Item 10.2.1

BURNSIDE PHASE 13

Regional Watershed Advisory Board

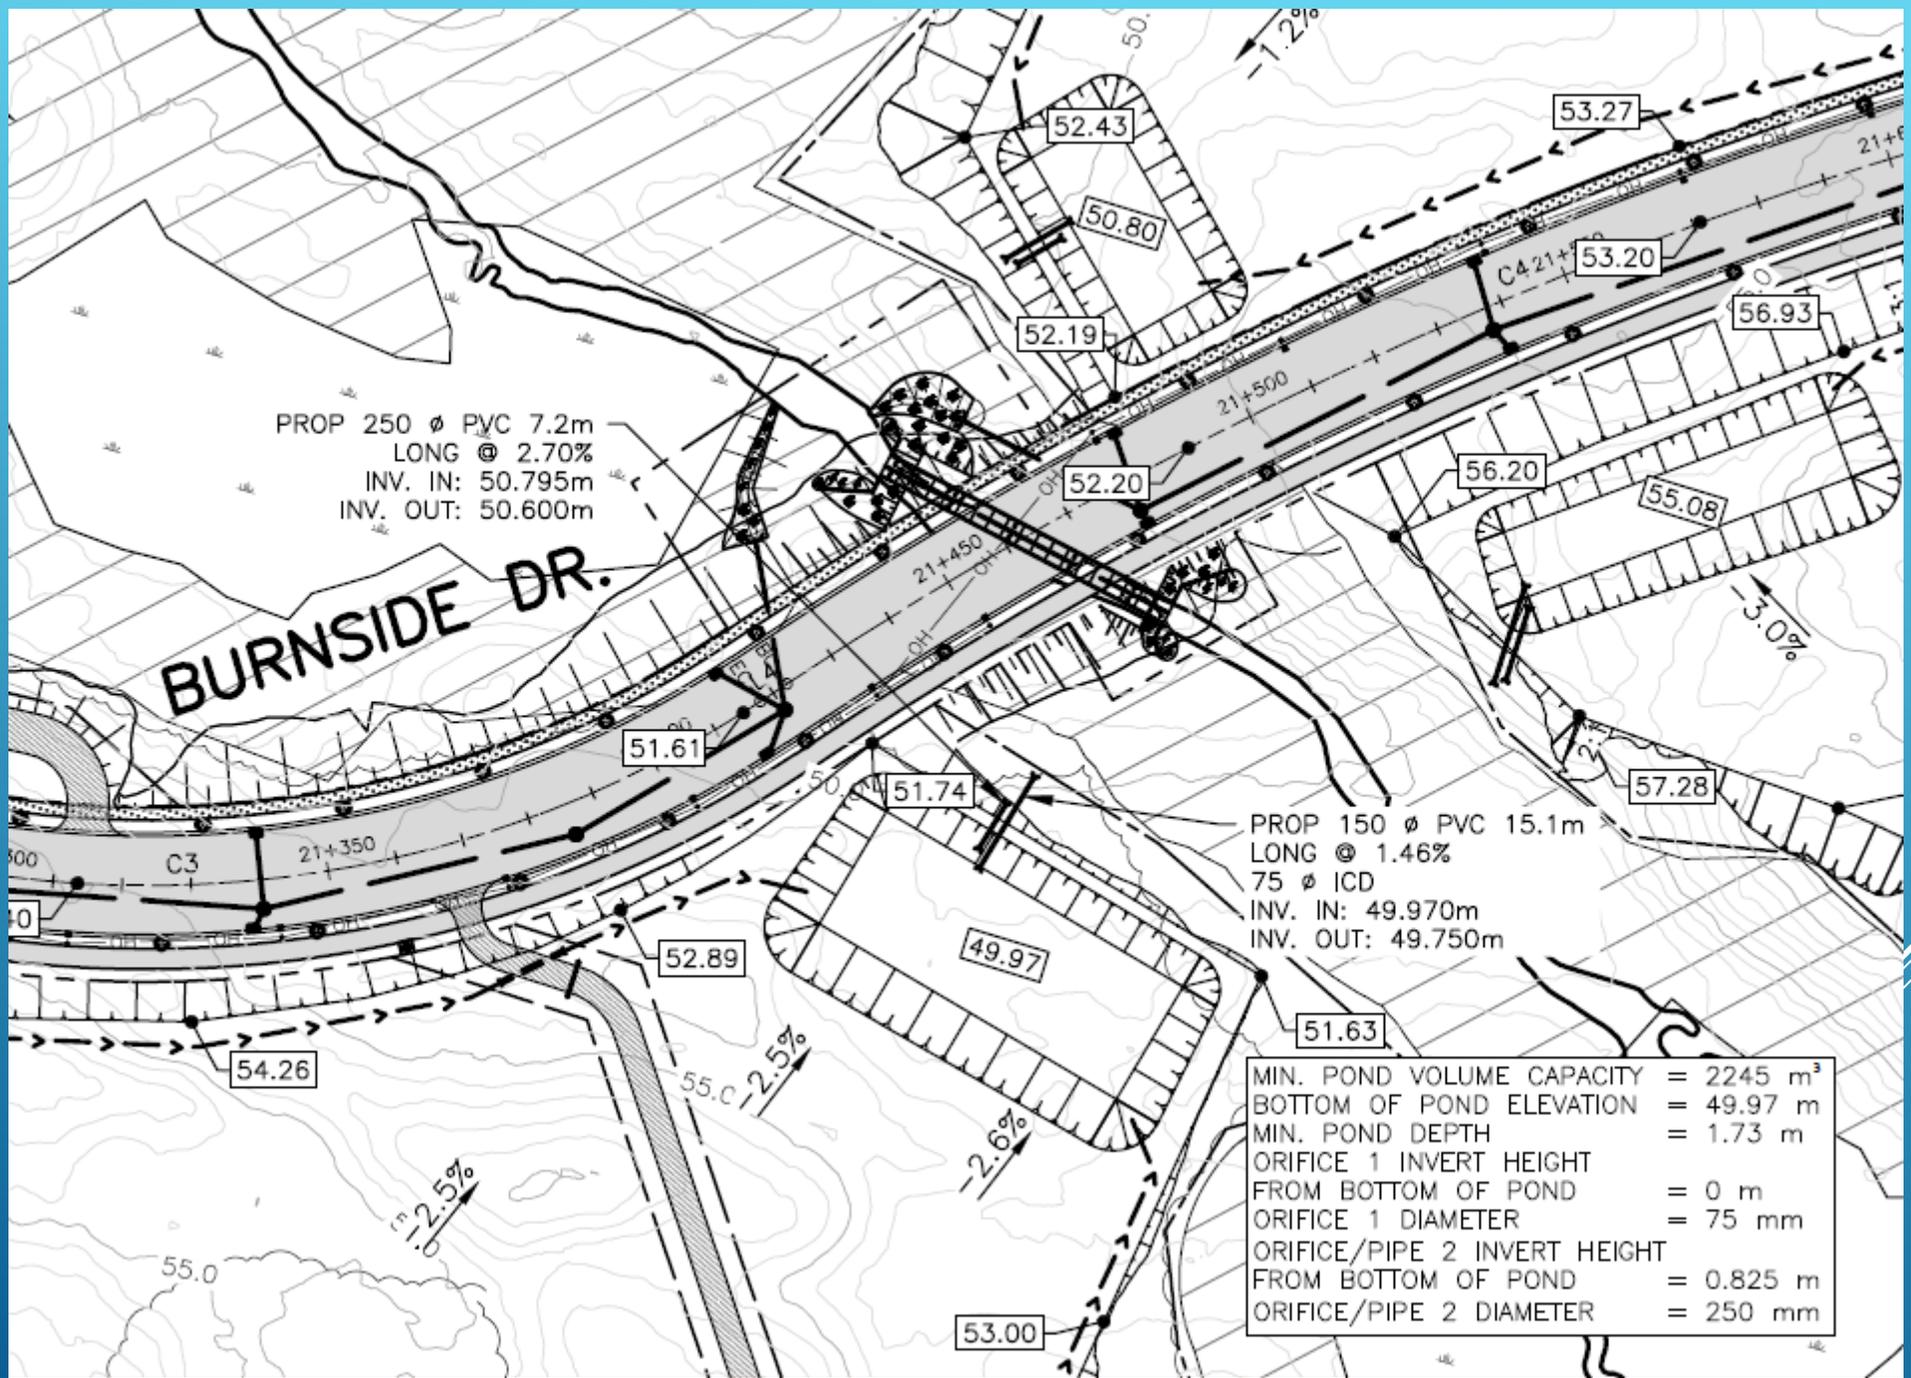
If there are to be any new discharge points for stormwater to the natural environment, where will they be, how will that stormwater be treated, and what are the predicted impacts to the receiving waters?

There are three new discharge points to MacGregor's Brook. During construction, the Contractor will manage runoff via the EPP measures that have been designed for the project. After completion of construction of the development and before the final development of each individual lot, temporary storage ponds have been provided to reduce runoff rate. Final development of the individual lots will require adherence to HRM's policies for net-zero runoff and treatment requirements.
